PROJECT: VALLEY AVE TRUCK YARD  
1106 Valley Ave NW, PUYALLUP, WA 98371  
1042 Valley Ave NW, PUYALLUP, WA 98371  
PARCEL #: 04220163042

DRAWING CONTENTS  
**PLANTING PLAN**  
DRAWING NO.: L1  
1 OF 4

CITY OF PUYALLUP  
Planning Division  
Approved Landscape Plan  
(253) 864-4165

DRAWING CONTENTS: LANDSCAPE DETAILS & NOTES  
DRAWING NO.: L2  
2 OF 2  
ORIG. SHEET SIZE 22X34

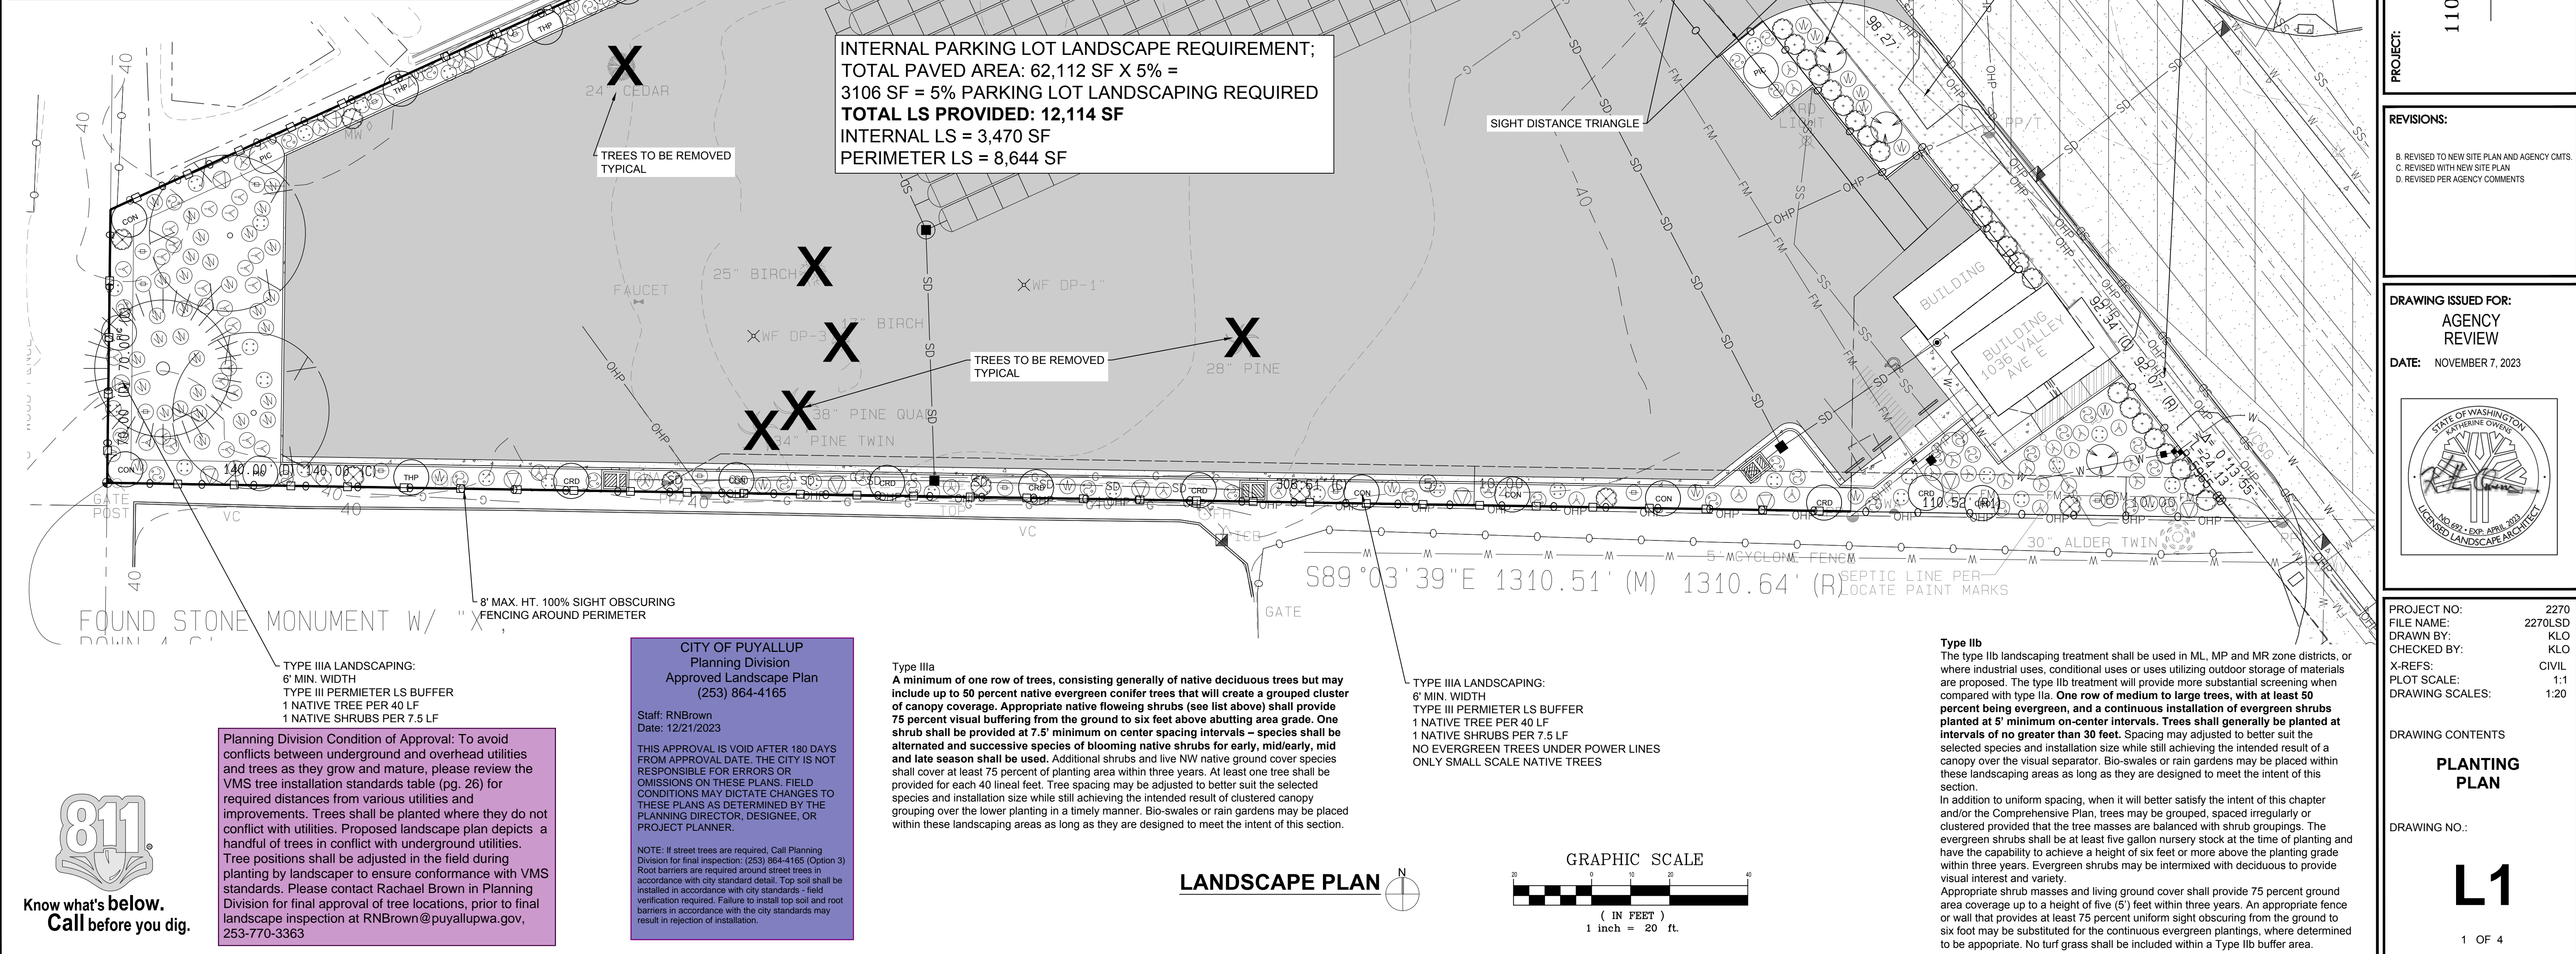
Planning Division Condition of Approval: To avoid conflicts between underground and overhead utilities and trees as they grow and mature, please review the VMS tree installation standards table (pg. 26) for required distances from various utilities and improvements. Trees shall be planted where they do not conflict with utilities. Proposed landscape plan depicts a handful of trees in conflict with underground utilities. Tree positions shall be adjusted in the field during planting by landscaper to ensure conformance with VMS standards. Please contact Rachael Brown in Planning Division for final approval of tree locations, prior to final landscape inspection at RNBrown@puyalupwa.gov, 253-770-3363

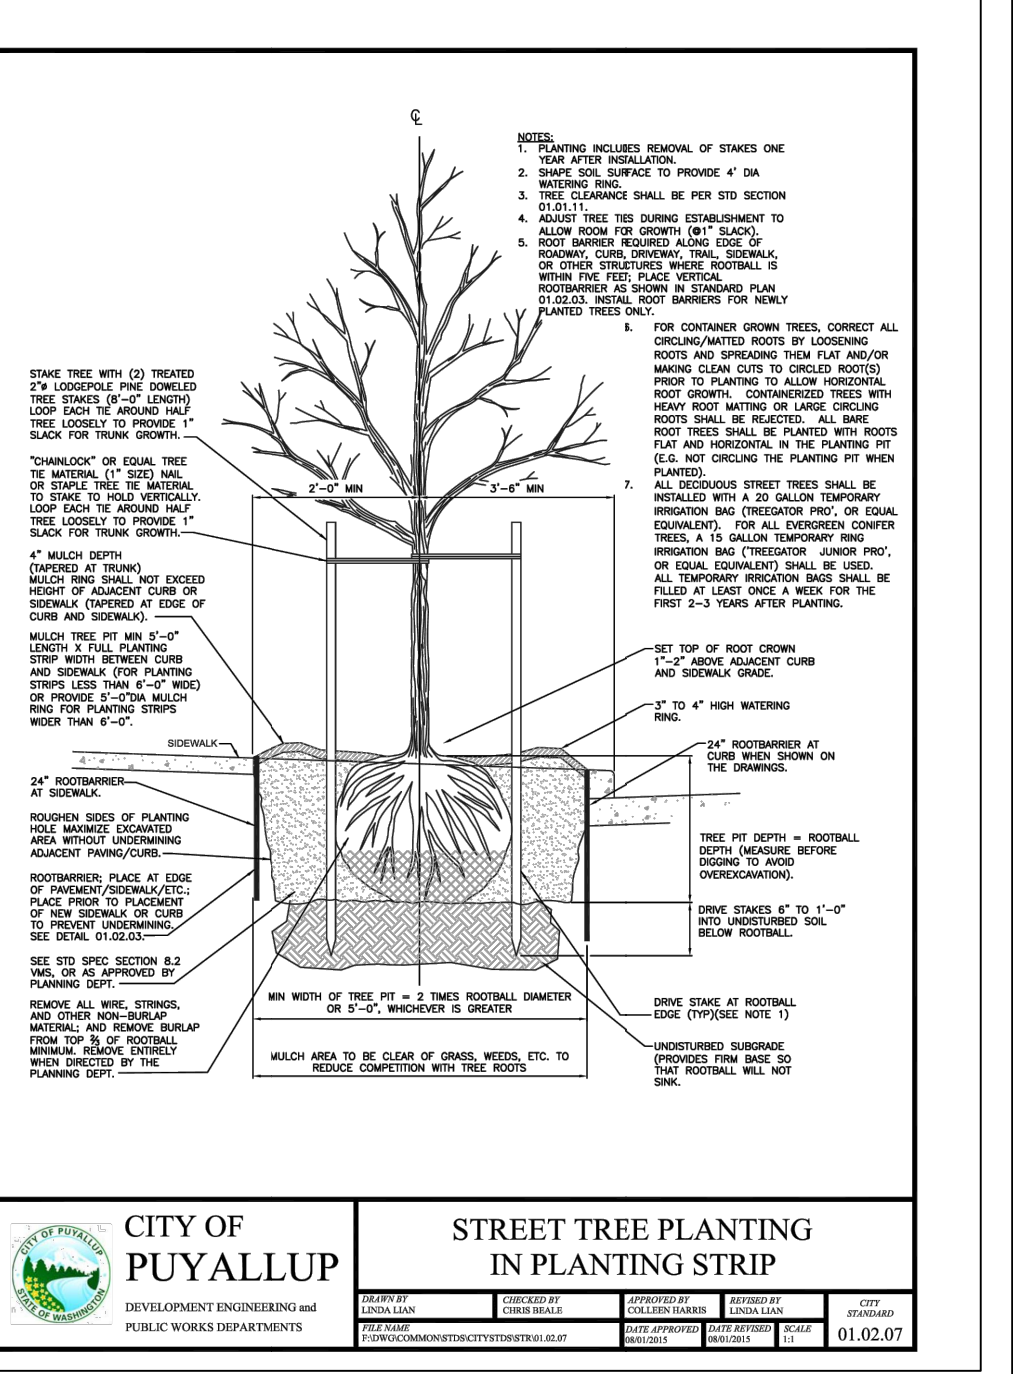
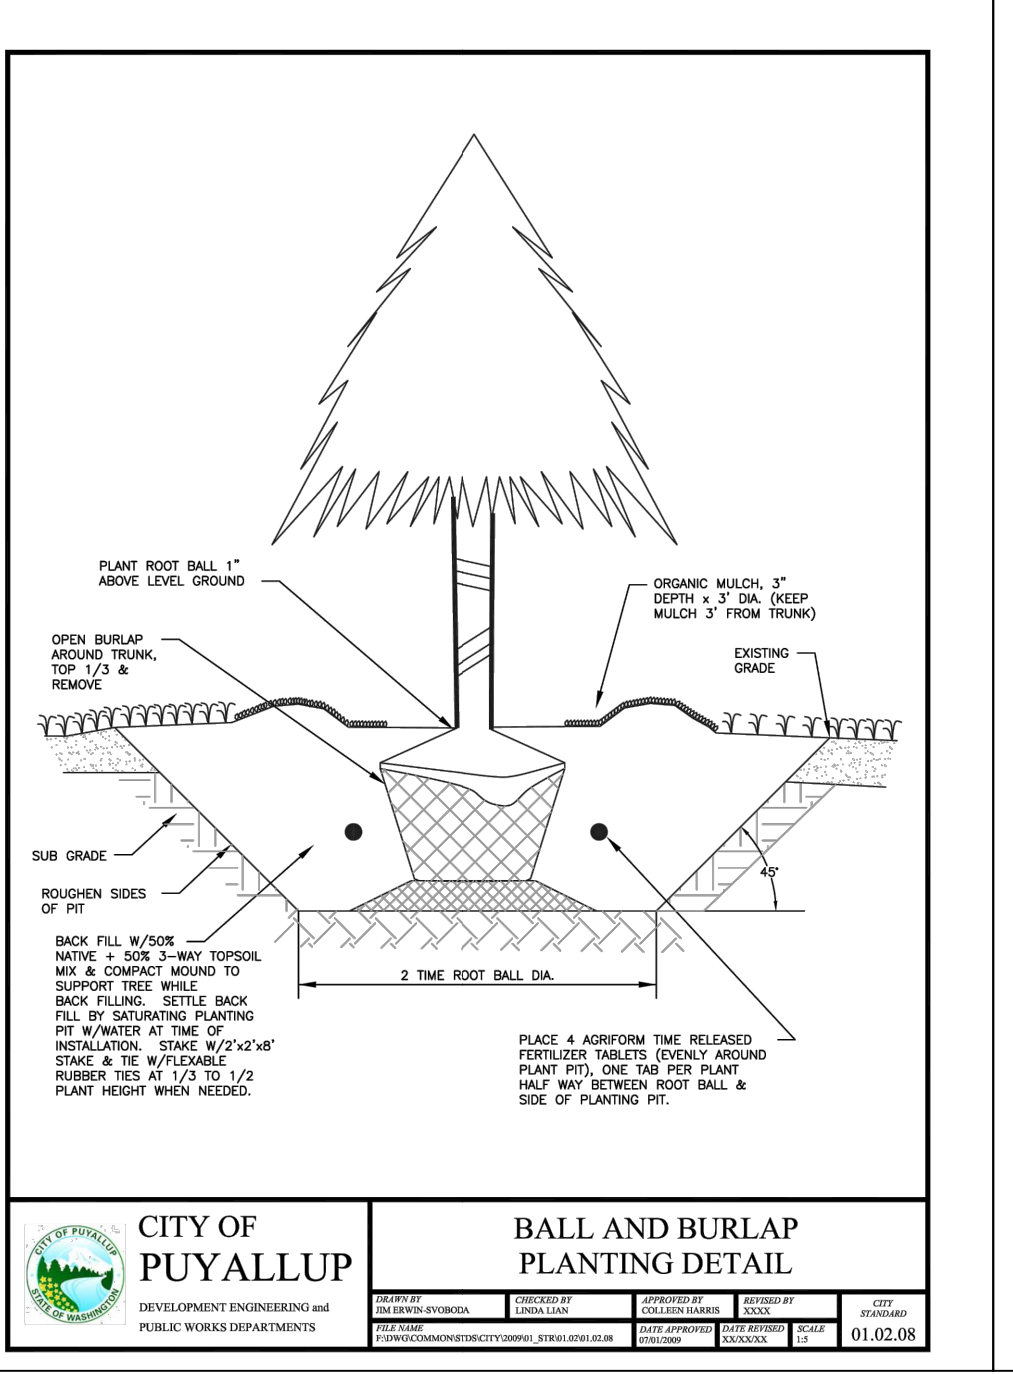
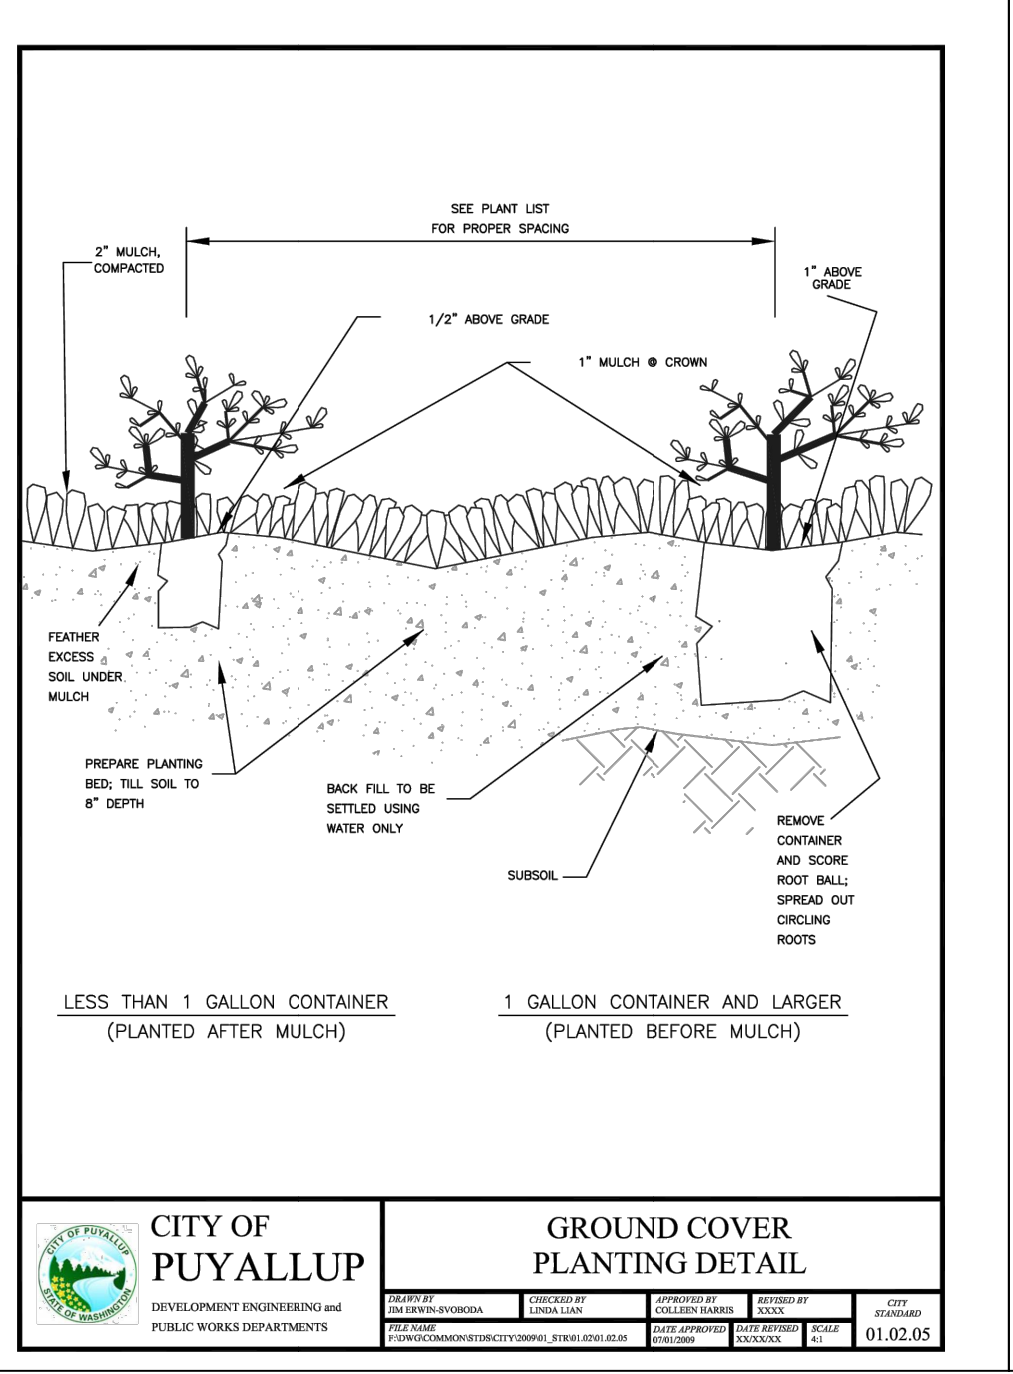
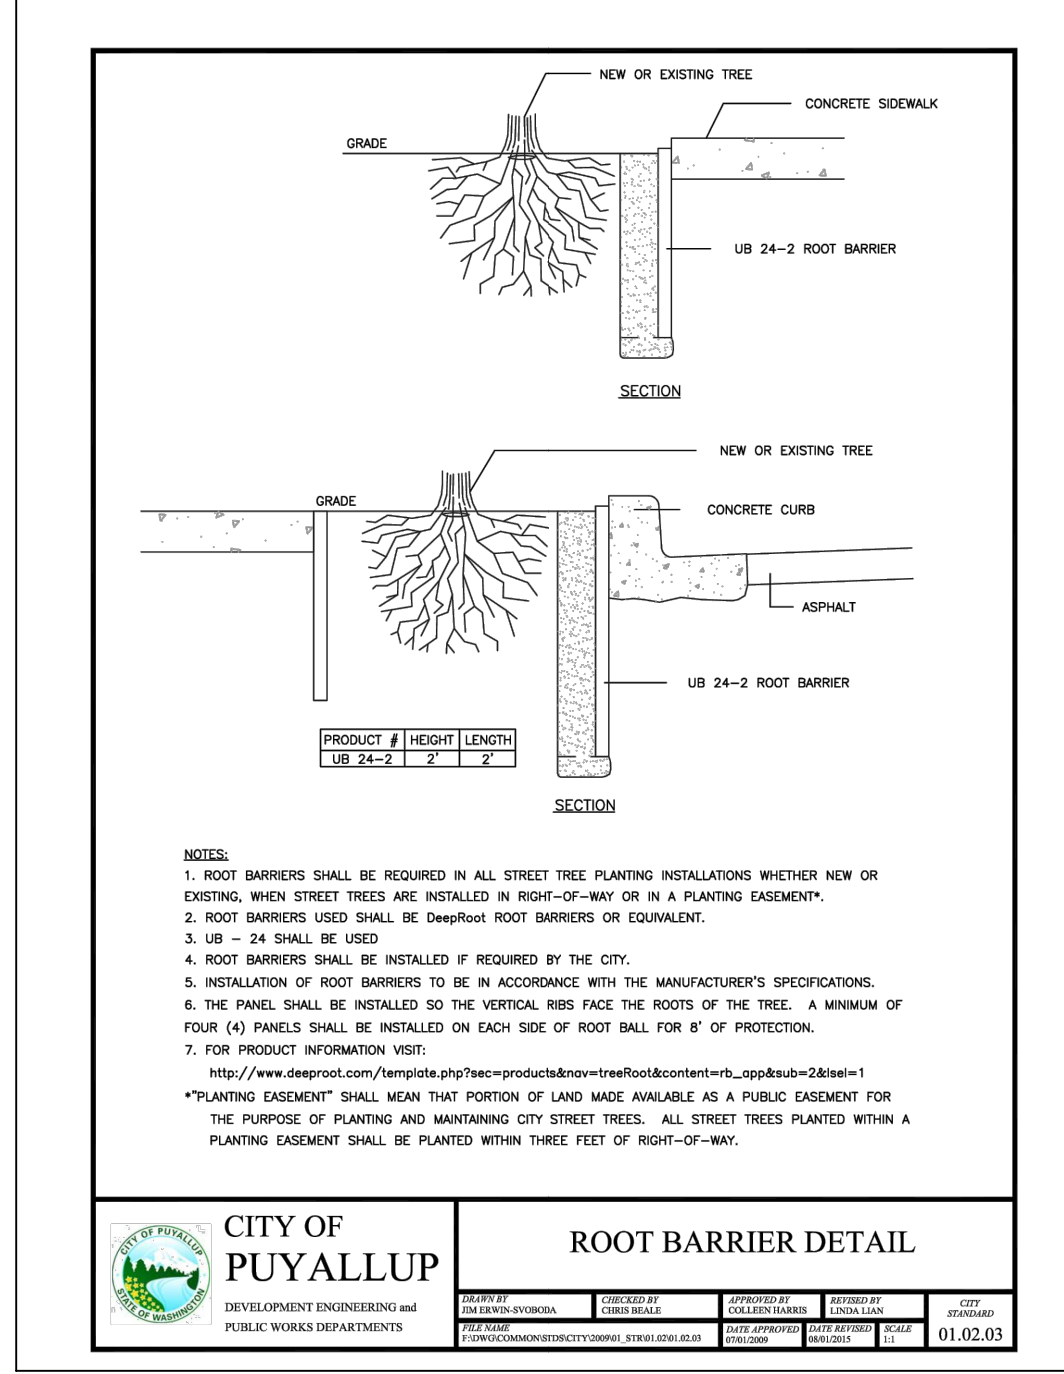
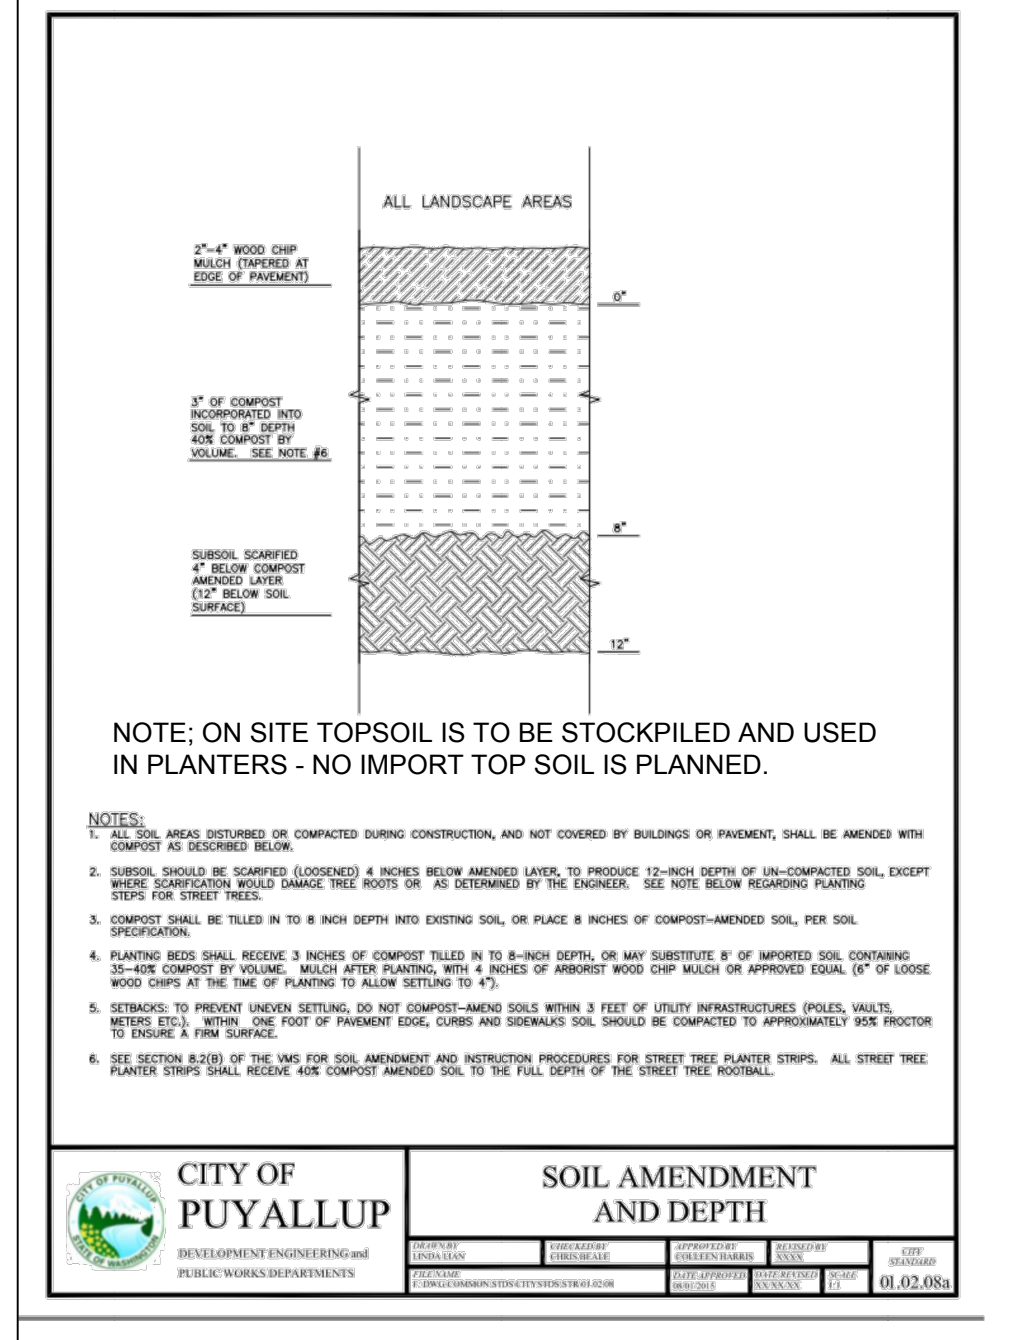
**Planning Division Condition:**  
Stockpile existing topsoil during grading, and replace it prior to planting. Stockpiled topsoil must also be amended if needed to meet the organic matter content of ten percent dry weight, either at a default pre-approved rate or at a custom calculated rate.
